ECN/PCN No.: M1321

Product Description: MOLDED INDUCTOR	Abracon Part Number / Part Series: AMPLA7030Q	☐ Documentation only ☒ ECN ☐ EOL	☒ Series ☐ Part Number
Affected Revision: Initial Release	New Revision: A	Application:	☐ Safety ☒ Non-Safety

3.0 Part Identification

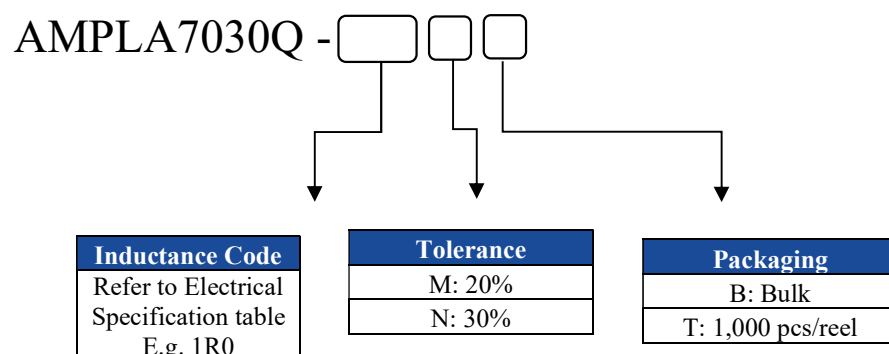
Prior to Change:

6.0 Part Identification

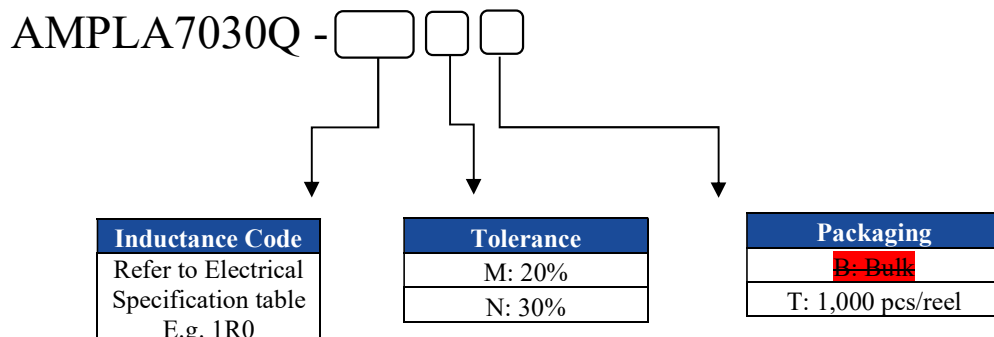
Cause/Reason for Change: Part Identification and Packaging sections were updated; R30 was added to the series.
